RECALL 21V876 REMEDY INSTRUCTIONS

Make(s): CARGO MATE & CONTINENTAL CARGO
 Model(s): MANY, SEE BELOW
 Model Year(s): 2021 - 2022

Concern:
 The 2 5/16" coupler may have components only spot-welded to it by the coupler manufacturer. This condition may lead to trailer separation from the tow vehicle.

FIGURE 3

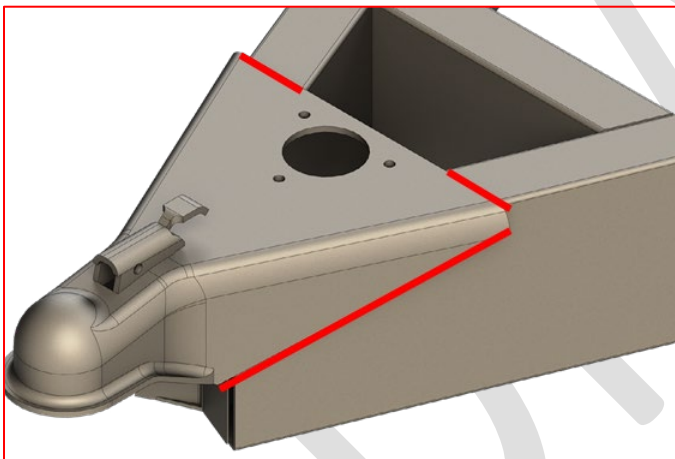
STEP 4: CUT THE EXISTING WELDS INDICATED IN *FIGURE 3 IN RED*. **DO NOT CUT INTO THE A-FRAME TUBES!** GRIND DOWN THE ROUGH EDGES AFTER THE COUPLER IS REMOVED. REMOVE AND DISCARD THE COUPLER APPROPRIATELY. ENSURE ALL AREAS ARE SMOOTH AND SHOW SHINY METAL WHERE THE NEW COUPLER WILL BE WELDED TOO;

FIGURE 4

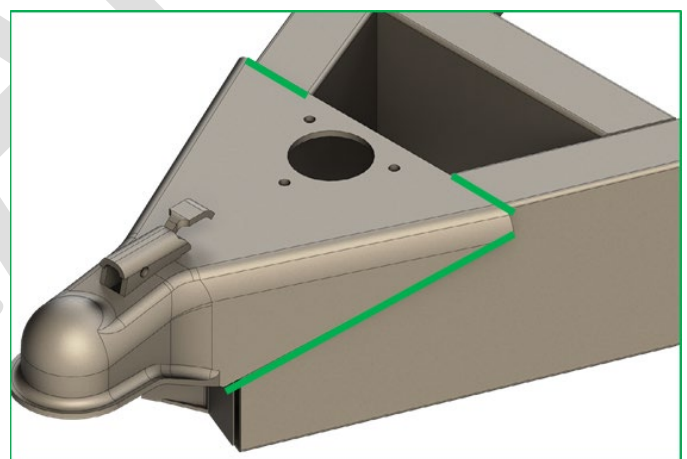
STEP 6: INSTALL THE REPLACEMENT COUPLER TO THE A-FRAME. WELD SMOOTHLY WHERE THE GREEN LINES ARE IN *FIGURE 4*. **DO NOT WELD AROUND THE TUBE RADIUS OF THE A-FRAME TUBES;**
